PORC	January 24 1 pm Walnut	06- 004
Chemistry	Unplanned Environmental Tritium Releases Root Cause Report #428868 UFSAR req't 300 ci/unit but BW does 1200-5000 ci/unit?	Dudek Ambler Walrath Wrigley Smith Gayheart Daly Leasure

ROOT CAUSE REPORT

TITLE: INADEQUATE RESPONSE TO UNPLANNED ENVIRONMENTAL TRITIUM RELEASES FROM BRAIDWOOD STATION DUE TO THE LACK OF INTEGRATED PROCEDURAL GUIDANCE.

Unit(s): Braidwood Units 1 and 2

Typical vacuum breaker:

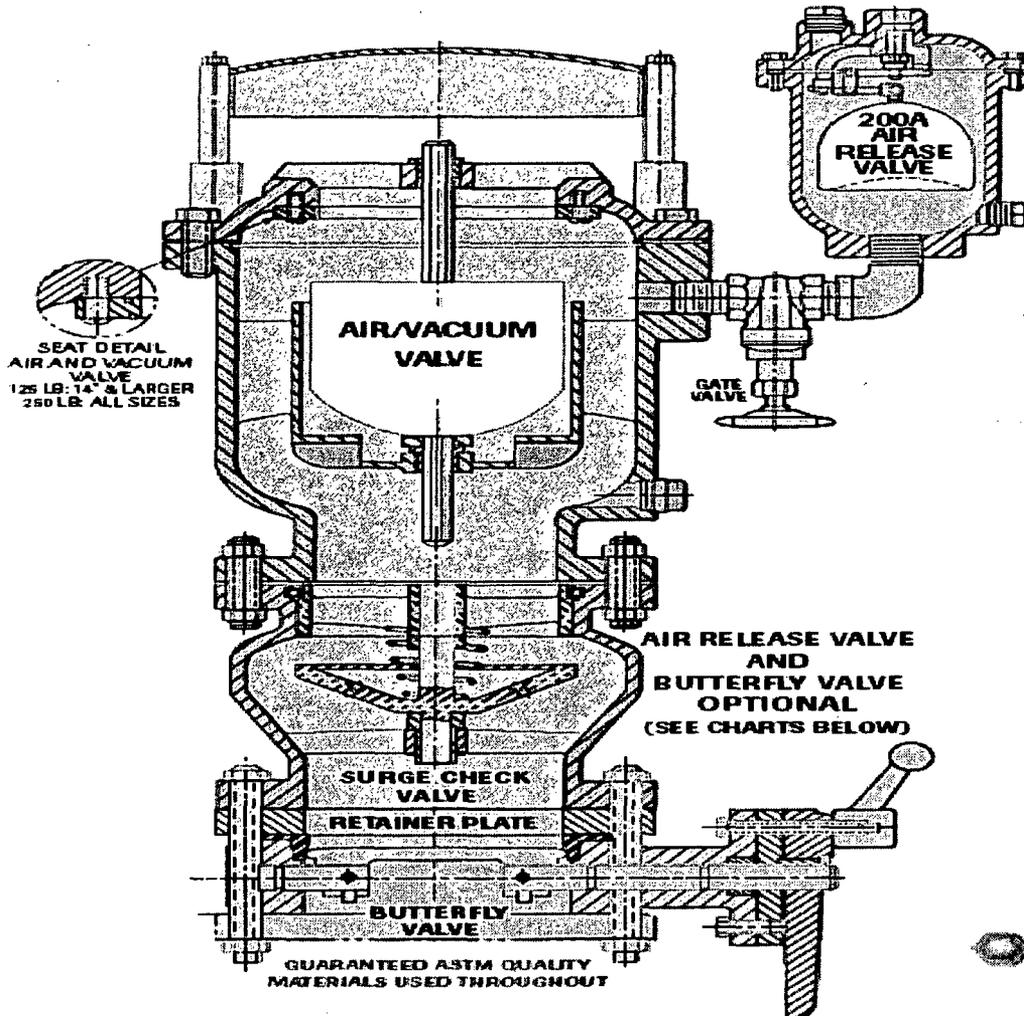
no closing comment on the relevance of these modifications
